ENGINEERING CHANGE NOTICE

DART AEROSPACE LTD

Date: 08.12.09	Job No.:	ADR Yes/No: N	ADR Date:	ECN #: 08- 578
Product No.: D350-616		Created By: <i>MP</i>	Approved By:	
Product Name: Emergency Litter Kit Installation		Checked By: <i>MP</i>	General Manager Approval:

- Release of D350-616 Rev. E on ECN 08-570 wasn't clear
- D2350 Bracket is replaced by D3179-041 Bracket, this affects the D350-616-011 and D350-616-013 kits. Update all IPPs per parts list of D350-616 Rev. E
- The D3179-041 bracket is necessary for compatibility with the Geneva Console.

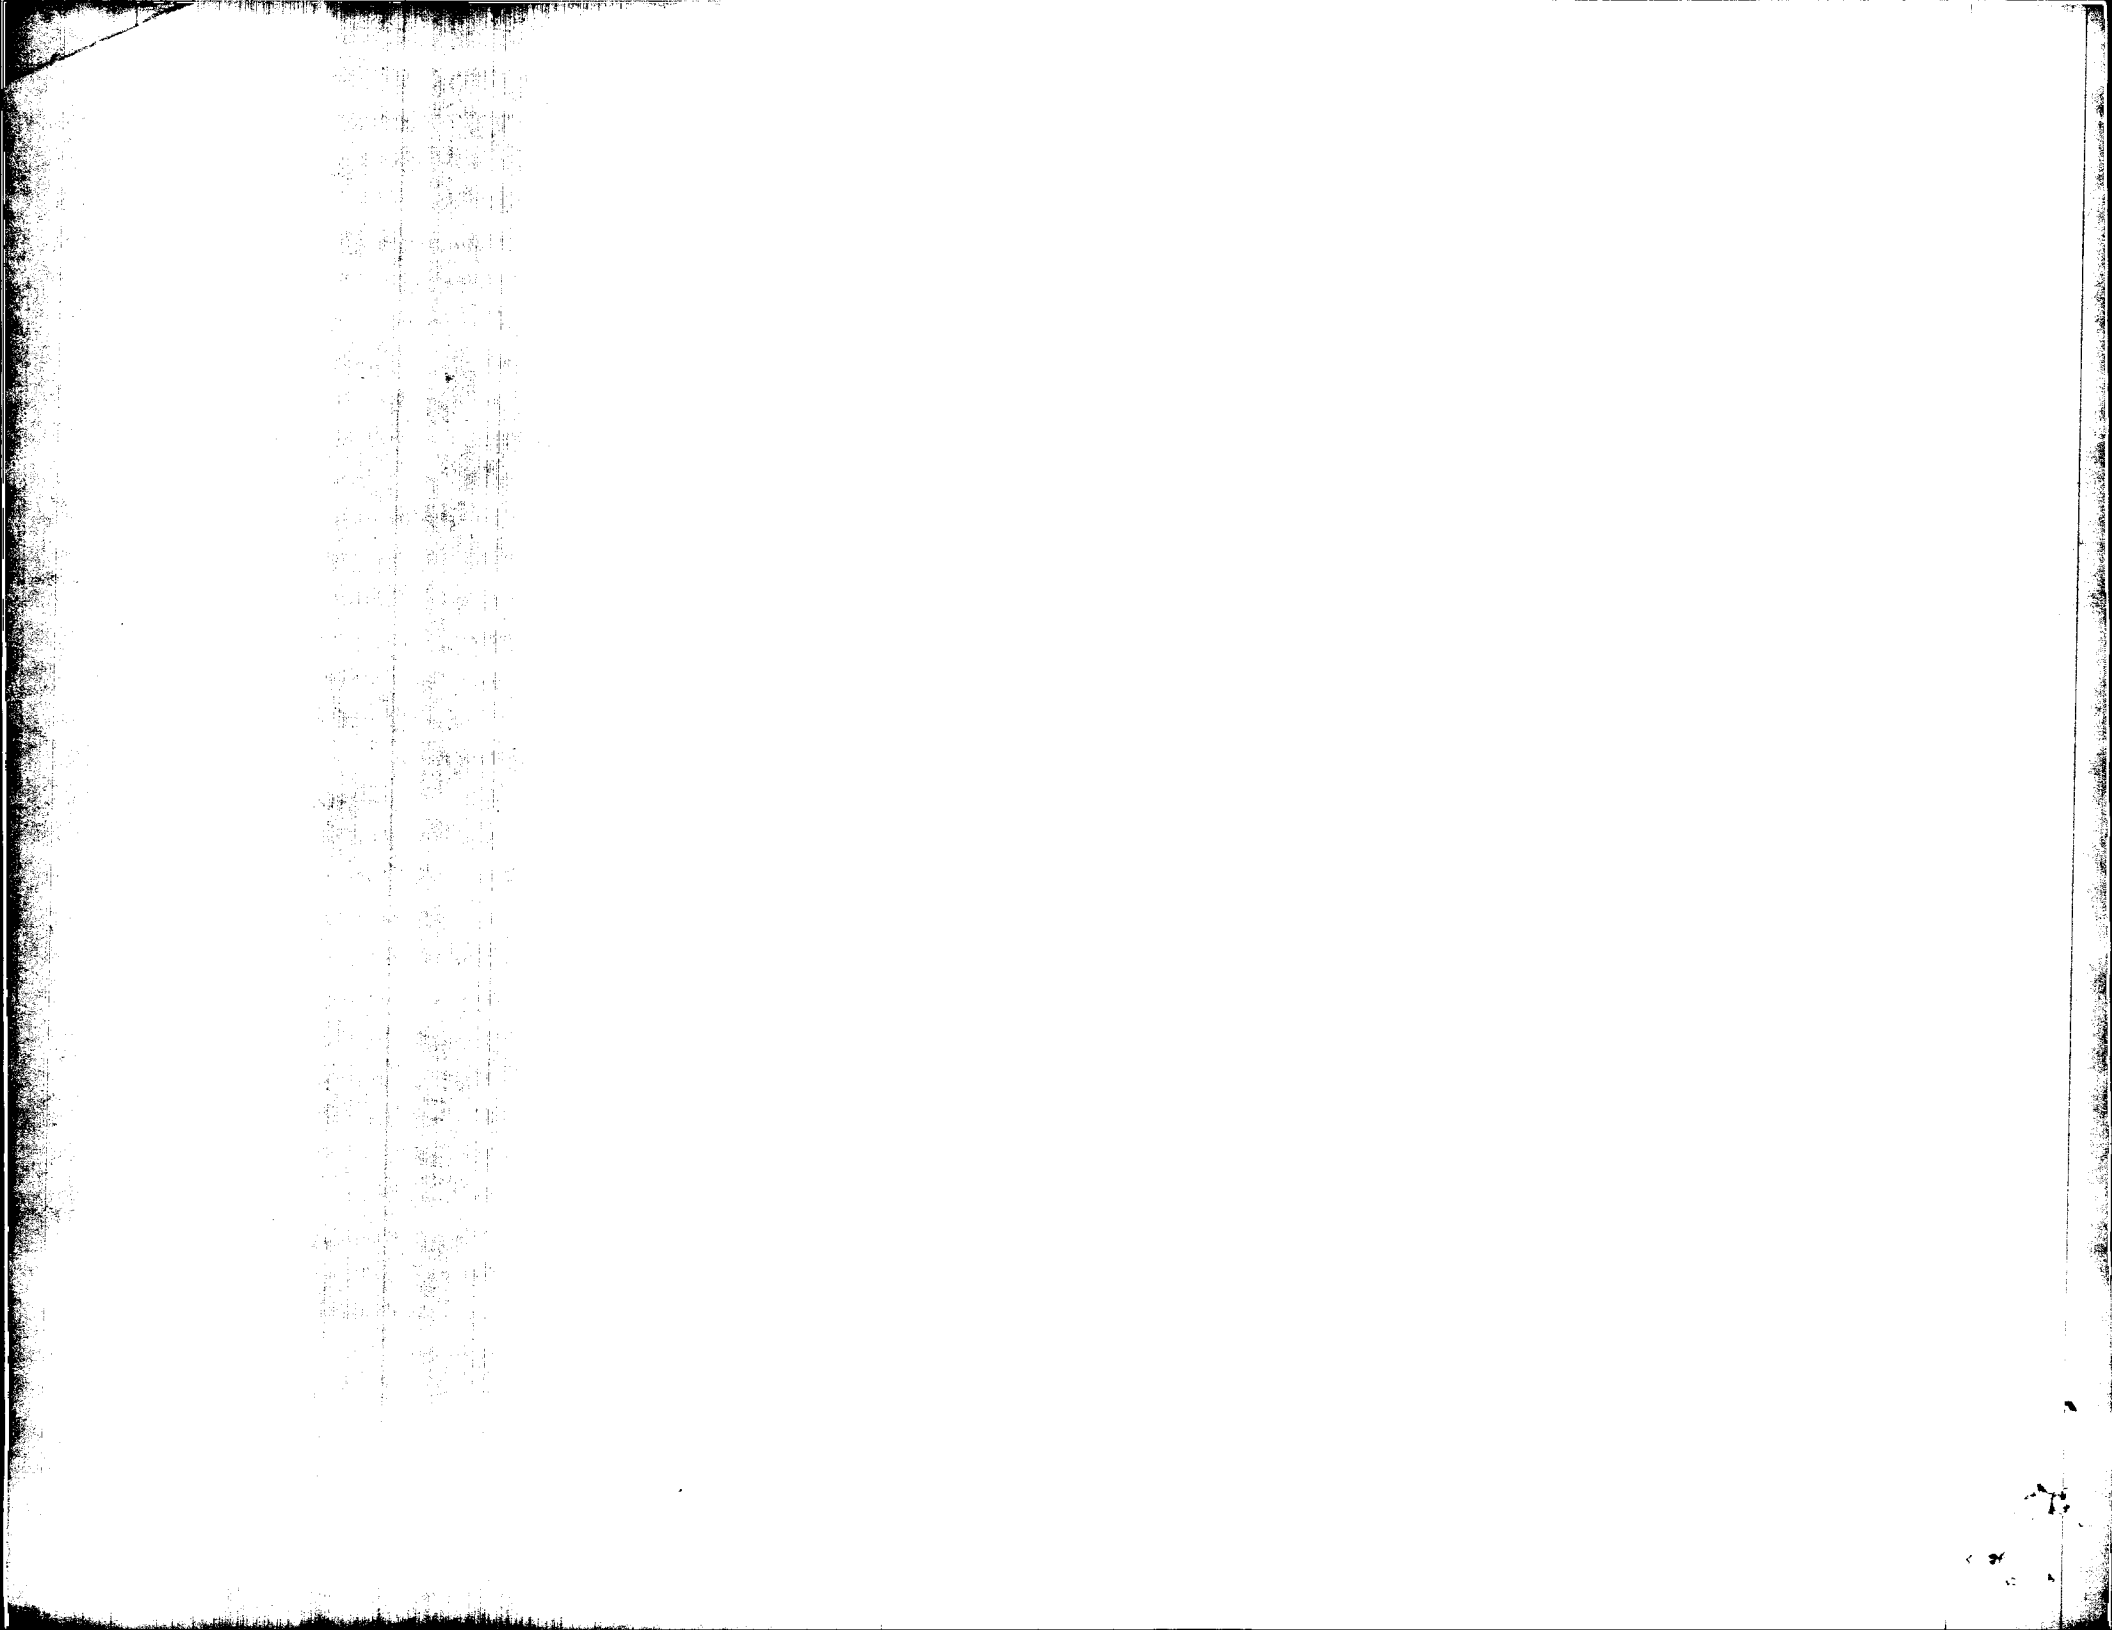
Reason for Change:
To make litter kit compatible with all aircraft.

Documents Affected:
Release D3179 Rev. C, D350-616 REV. E, IIN-D350-616 REV C
